PD Modification Application: PRS 22-1680

**Hillsborough
County Florida**

Development Services Department

AGENCY REVIEW COMMENT SHEET

8.2 Proposed Site Plan (Full)

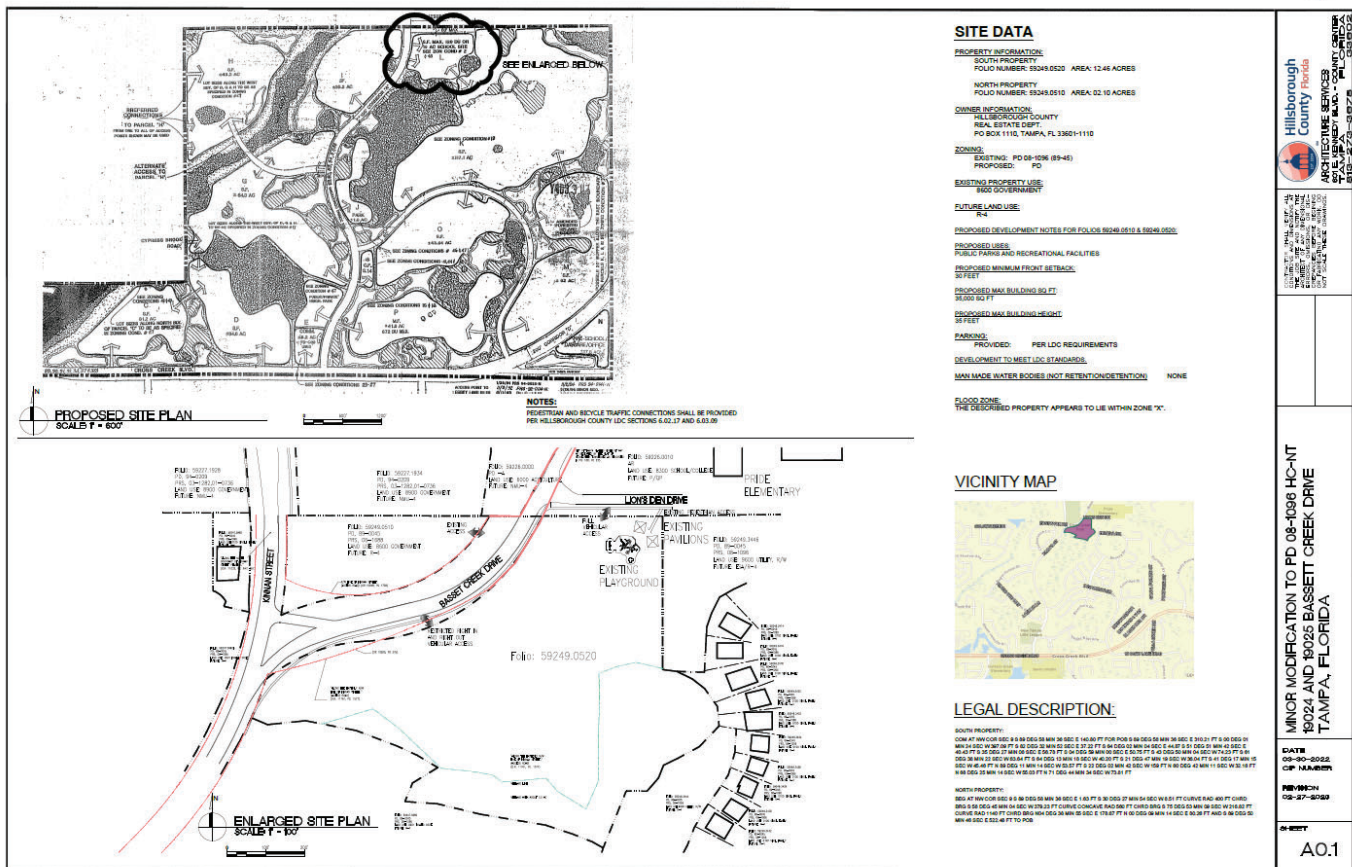
- Prior to PD site plan certification, the developer shall revise page 1 of the PD site plan as generally shown below, to remove the detail which conflicts with sheet 2 of the plan.

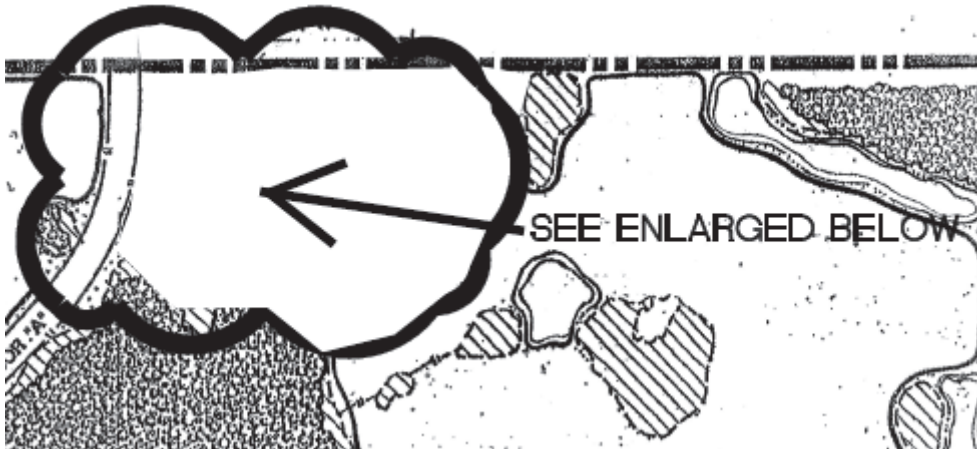
36. With the exception of development within Parcel L, ~~Aceess~~-access and internal road geometrics on major road corridors, in particular Cross Creek Boulevard and the North-South Connector, shall accommodate a 96" wide by 40' long advance design coach.

[Staff is recommending modification of this condition. Staff is unsure of the provenance of the original condition, but notes that certain project access may not be able to be designed to accommodate the referenced design vehicle, particular due to the separator being required by County staff as discussed hereinbelow].

Primary Access Generally

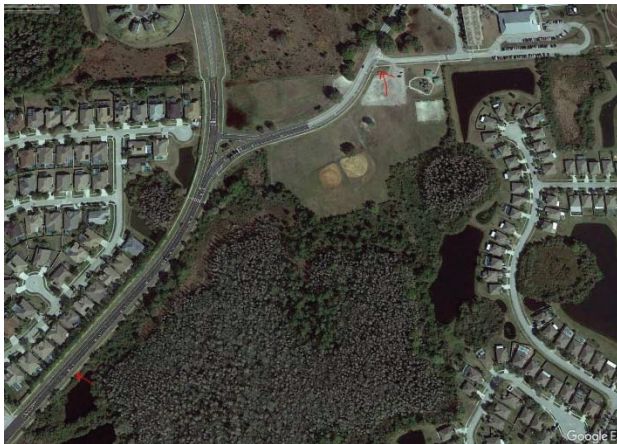
Primary vehicular and pedestrian access to Parcel L will remain via Bassett Creek Dr. Additional access to Lion's Den Dr. is also proposed. This access will be the sole means of egress for traffic leaving the southern portion of the site who wish to travel south on Bassett Creek Dr.

Additional pedestrian connection to Kinnan St. would be permitted, although no direct vehicular access to Kinnan St. will be possible due to the size and configuration of the parcel and functional classification of Kinnan St. and the roadway geometry proximate to the site.

TS-7 TYPICAL SECTION

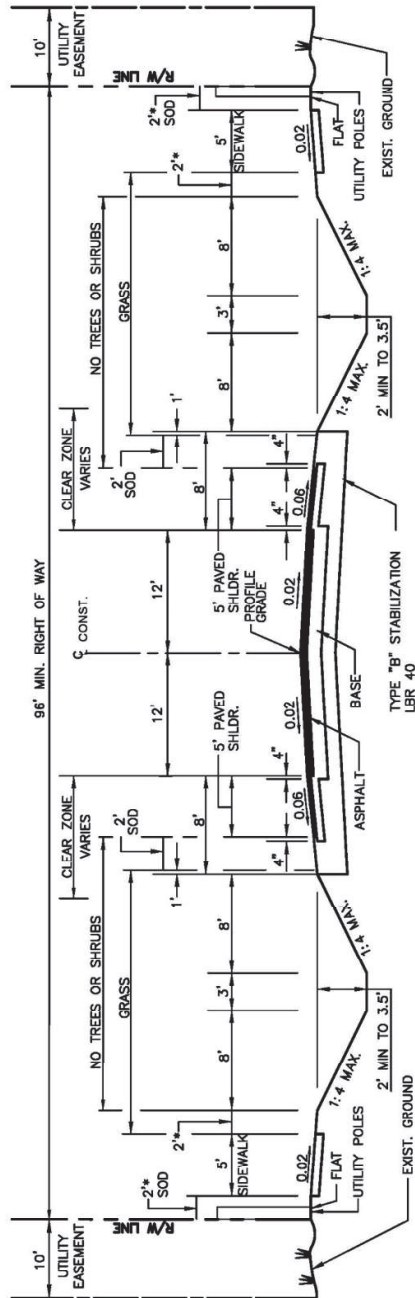
SHOULDERS: Bassett Creek Drive was found to have unpaved relatively flat areas adjacent to the edge of pavement (at a typical width of at least 5.0') that provide for vehicle refuge and thus function as shoulders. These areas are continuous along Bassett Creek Drive. It is unknown whether the referenced areas are stabilized. It is noted that off-tracking was not observed along Bassett Creek Drive, which would be indicative of the need for shoulder improvements. These findings indicate that Bassett Creek Drive has substandard shoulder conditions, as pursuant to Hillsborough County roadway standards for the applicable TS-7 typical section, the standard shoulder condition is identified as 5 foot (paved).
